City of Parramatta

**SECTION 4.15 ASSESSMENT REPORT**  
**Environmental Planning & Assessment Act 1979**

<b>DA No:</b>	DA/210/2023
<b>Subject Property:</b>	Lot 1 DP 1007573, 132 Victoria Road, North Parramatta
<b>Proposal:</b>	Demolition and construction of a 7-storey mixed use development to be comprised of 3 retail tenancies and 45 residential apartments, including affordable apartments, over 3 levels of basement parking. The application is made pursuant to the State Environmental Planning Policy (Housing) 2021. The development is Nominated Integrated pursuant to the Water Management Act 2000.
<b>Date of receipt:</b>	14 April 2023
<b>Applicant:</b>	JS Architects Pty Ltd.
<b>Owner:</b>	Mr M Mina
<b>Property owned by a Council employee or Councillor:</b>	The site is not known to be owned by a Council employee or Councillor
<b>Political donations/gifts disclosed:</b>	None disclosed on the application form
<b>Submissions received:</b>	None
<b>Recommendation:</b>	<b>Refusal</b>
<b>Assessment Officer:</b>	Eamon Murphy

**Figure 16.** Building section with height variance outlined in red area.

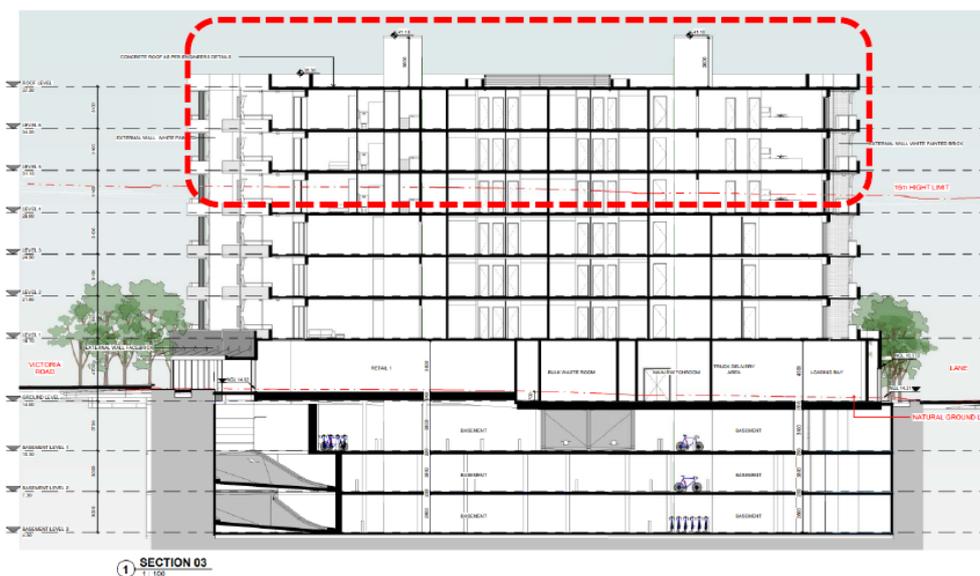
**Comment:** As shown in **Figure 15**, the elements of the proposed building which exceed the control, beyond the height plane, has not been integrated into the design of the development which currently presents as ‘bulky’ due to the excessive footprint. Additional information, in terms of the context, with regard to surrounding built form, has also not been submitted demonstrating the impacts of the proposal on adjoining properties.

**Comment:** Compliance with the development standard is reasonable in the circumstances of the case. The elements that protrude beyond the maximum height plane has not been satisfactorily integrated / designed into the development to ensure that a breach to the height standard does not occur. The proposal in its current form with the addition of an excessive building footprint results in a bulk and scale in this location which was not envisaged by the controls. Further, it does not contribute positively to the streetscape presentation nor to the character of the area.
